FINAL Environmental Impact Statement Newmont Mining Corporation's South Operations Area Project Amendment

Appendix E Public Comment Letters and Responses

RESPONSES TO PUBLIC COMMENTS ON SOAPA DEIS

Figure 35: Groundwater contours for layer 14 for scenario 3 after 61 years

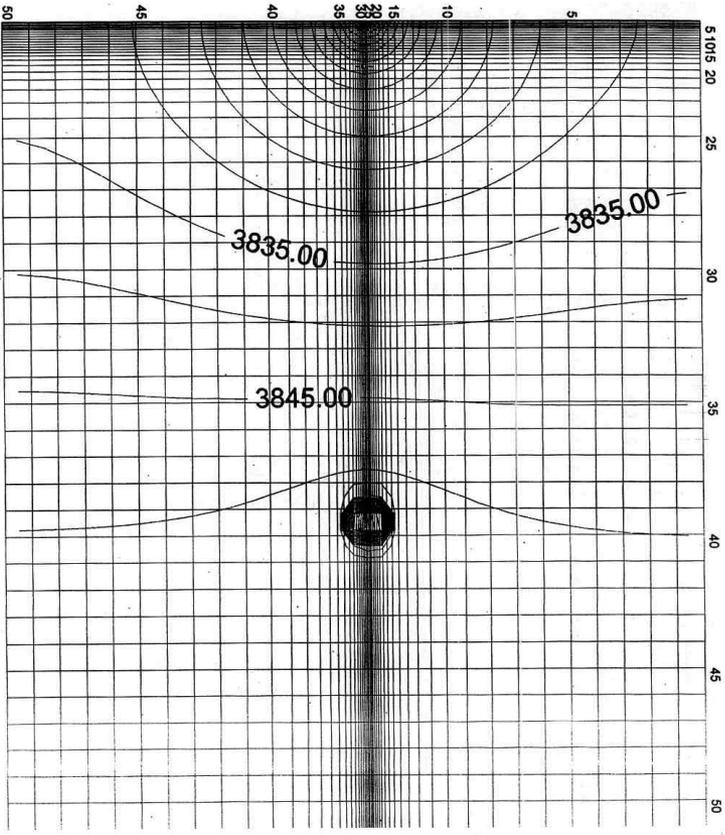
In layer 15 just after the maximum drawdown is reached, contours indicate a relative gradient from 3660 at the hole to 2900 near the GHB (Figure 34). A divide forms between the hole and GHB in layer 14 (Figure 35). Water drains through the layers near the GHB, but more flows through the hole. In layer 14, flow through the hole is 56,400 ft³/d, while flow through the top of the layer is 80300 and through the bottom is 138,000 ft³/d. The difference is due to a 57000 ft³/d release from storage. By layer 13, a slight gradient to the GHB still exists, but the hole causes a massive drawdown (Figure 36). Flow through the hole is 56400 ft³/d while through the top of the layer flow is 61,900 ft³/d and 80,300 ft³/d through the bottom of the layer. Flow through the upper layers and the hole are equal at 55,400 ft³/d.

Figure 1: Pit lake inflow by layer for the scenario without mitigation.

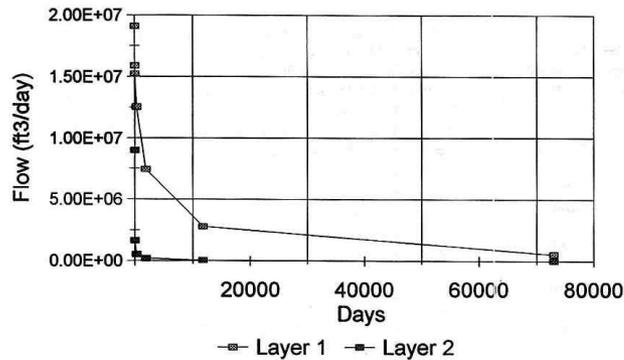
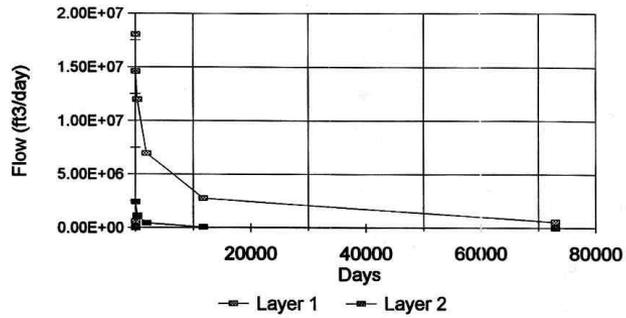
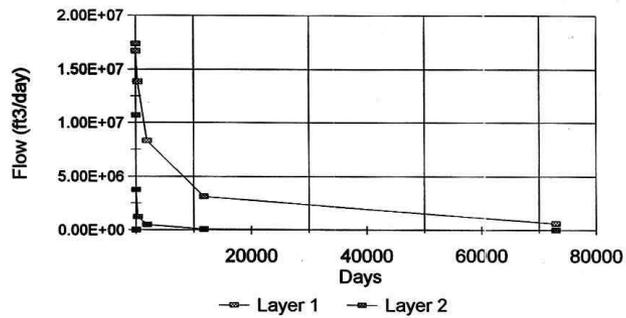
Figures 1 through 3 show the rate of pit lake inflow by layer. Without mitigation, most of the flow returns from layer 1 even though the pumpage from 1998 through 2011 removed equal amounts from each layer. A probable reason is that the storage coefficient is specific yield; the pressure in the lower layers causes a vertical flow upward into layer 1. During the first year, upward flow was 7811828 ft³/d for the no mitigation alternative and 6630252 during the steady state analysis. The steady state rate is high because the primary discharge from the steady state model is to ET; the additional 9900 af/y is to the pit lake. Injection increased the flow from layer 2 into the pit lake, but it was not substantial (Figure 2). Infiltration increased the rate to the pit from layer 1 by about 20% (Figure 3). Total pit inflow is 95, 85, and 96% from the top layer for the without mitigation, injection, and infiltration alternatives.

Figure 4: Flux to various streams during recovery for the without mitigation scenario.

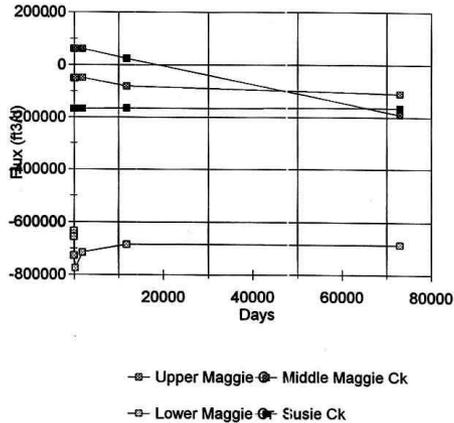
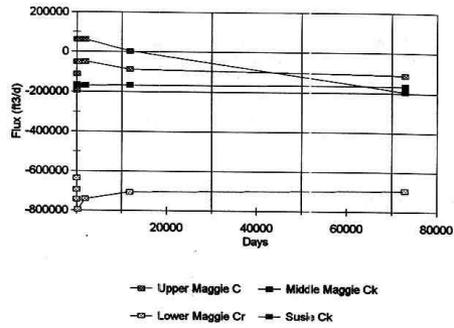
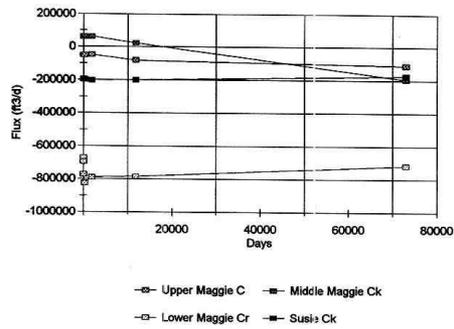
Lower Maggie Creek has an approximate 5% increase in flux to it over the long term.

Susie Creek has only slight improvements. With infiltration, fluxes increase faster, although on Maggie Creek the ultimate rate is approximately the same. The biggest change is on Susie Creek which almost immediately increases by 0.2 cfs.
